DA2024/194

55 CROOKED BILLET DRIVE, BRIDGEWATER

EXTENSION TO EXISTING WAREHOUSE

IN RESPONSE TO THE REQUEST FOR FURTHER INFORMATION

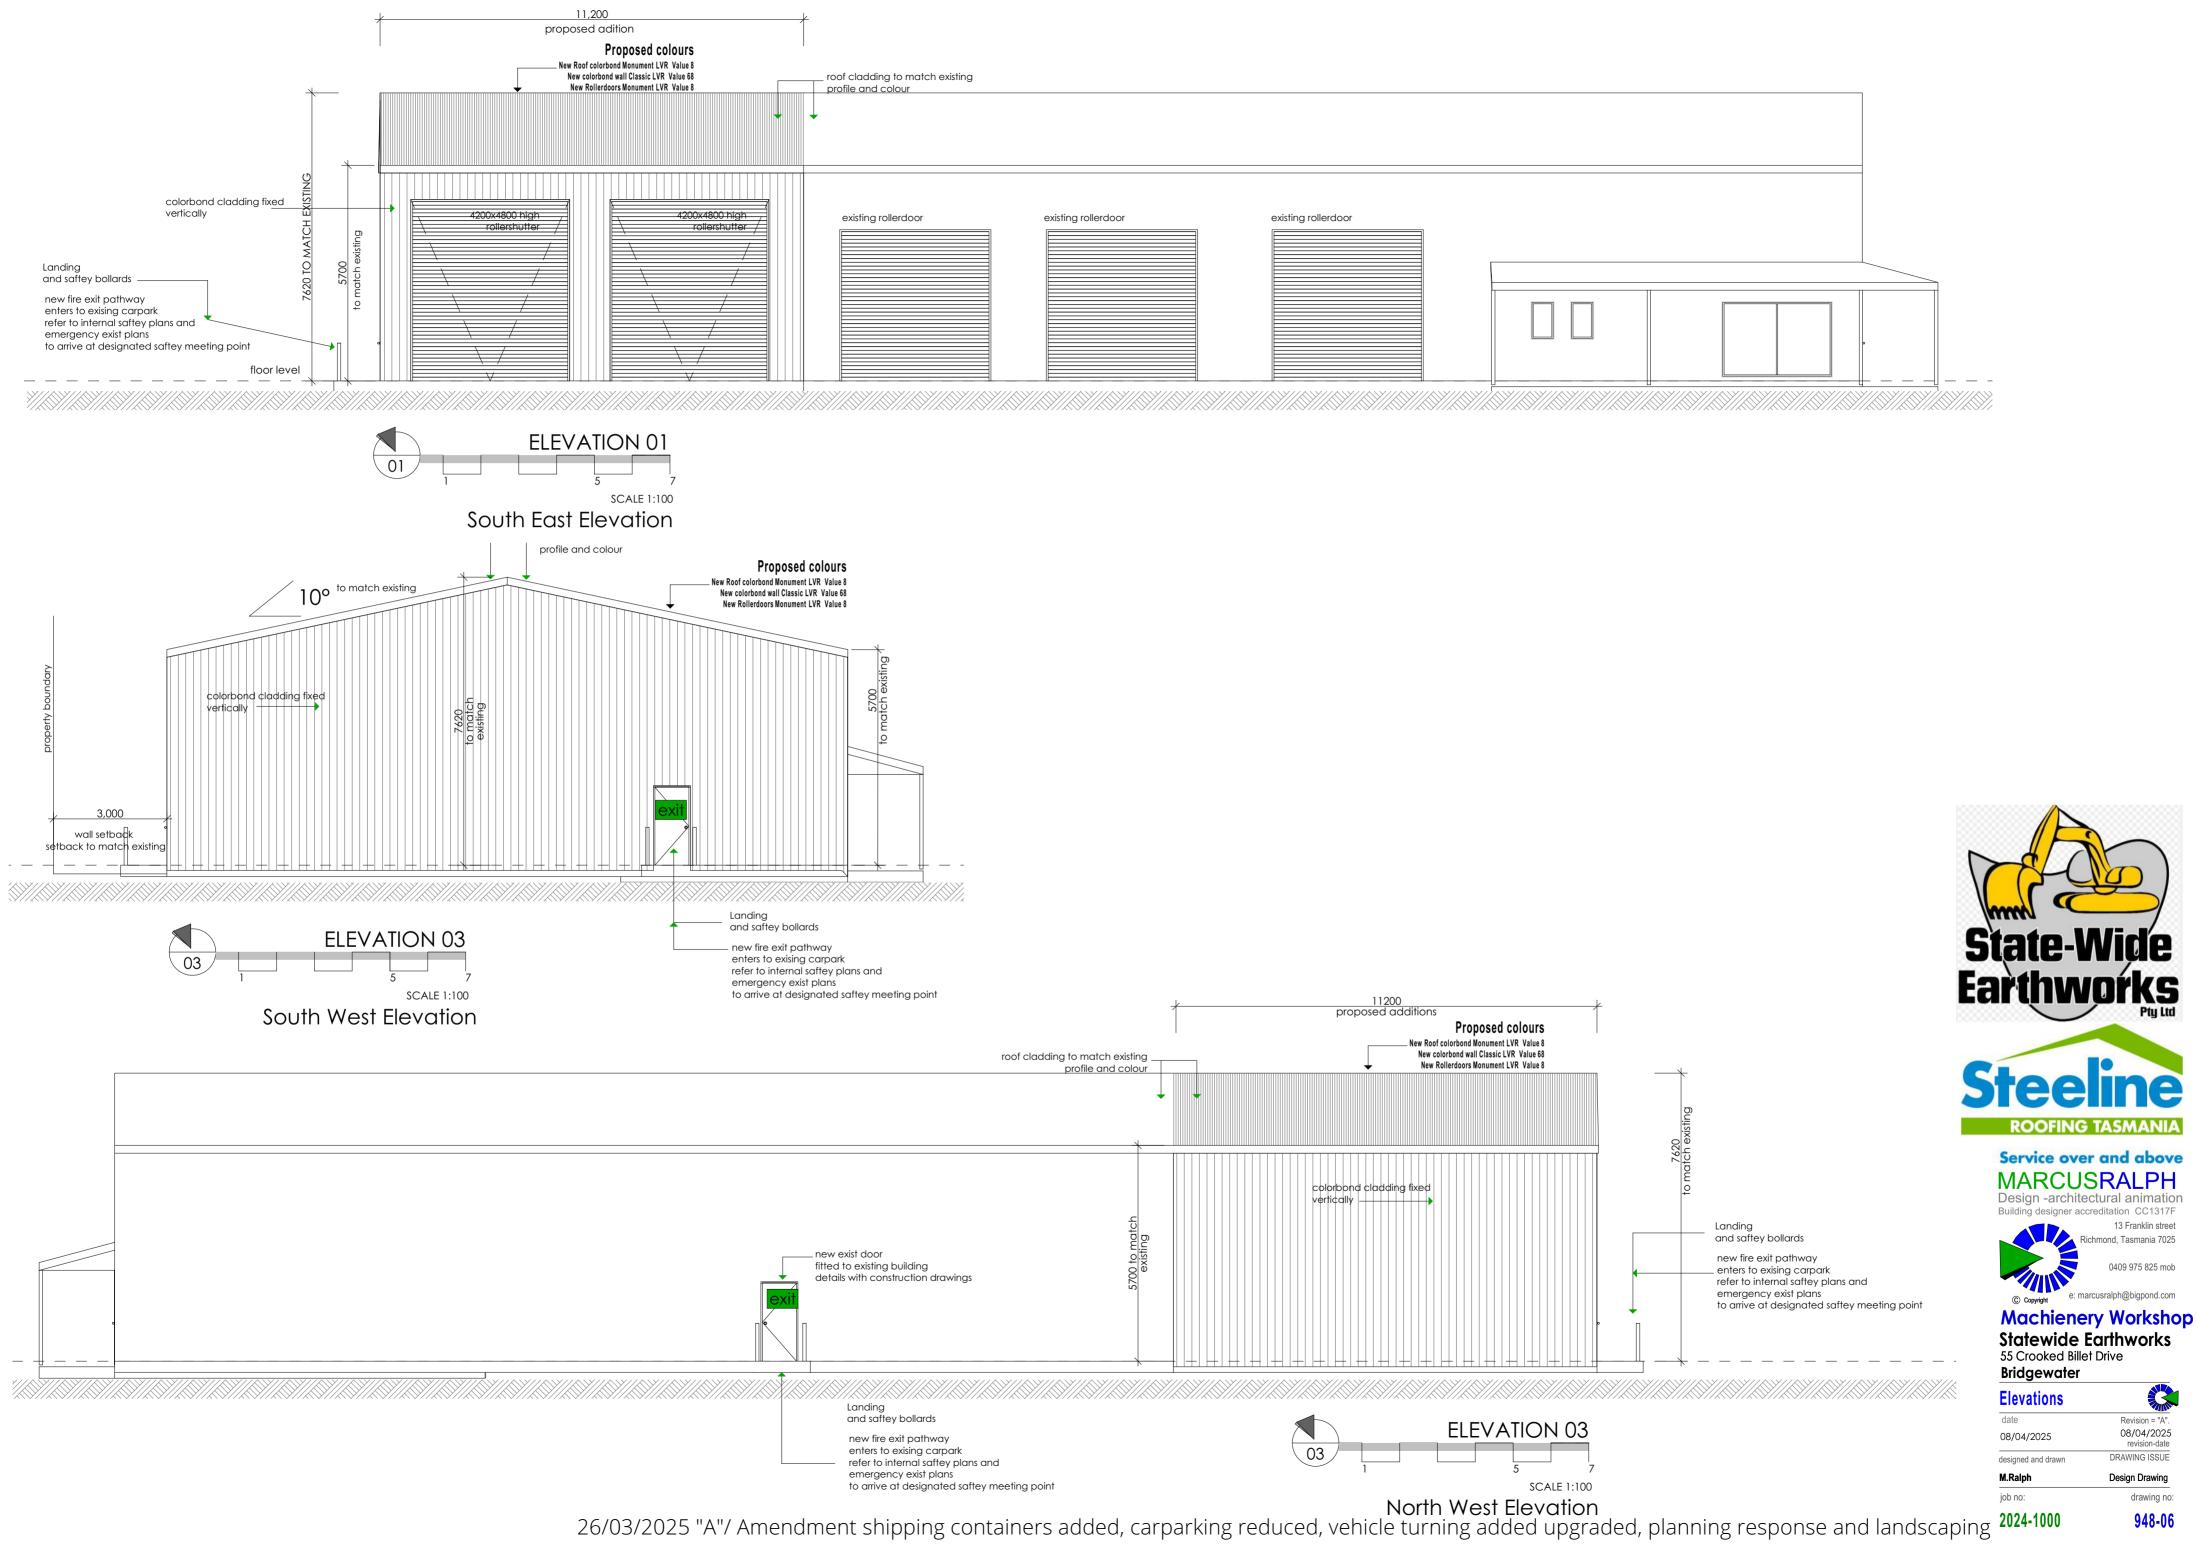
Referring to the Drawing 948-09, please demonstrate access to car spaces 15-17. Reason: Existing fuel bunding appears to restrict access.

The existing development at present exceeds the total number of car spaces required Car space 15-17 currently shown on the design plans will be removed

Figure 1 – Aerial imagery indicating shed location relative to existing concrete slab, and building designer dimensions of proposed extension

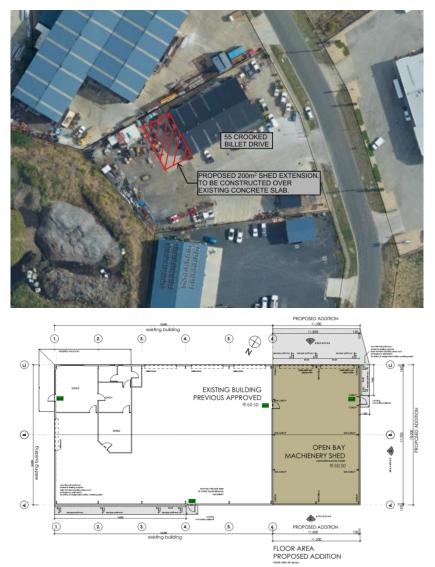
"Stormwater discharge from the site will need to be limited such that there is no increase in peak flows for up to a 2% AEP event over existing".

The proposed shed extension occupies an area of approximately 200m² and is to be constructed over an existing area of concrete hardstand (Figure 1). The runoff from the site will not increase because of the development and stormwater detention is not required.
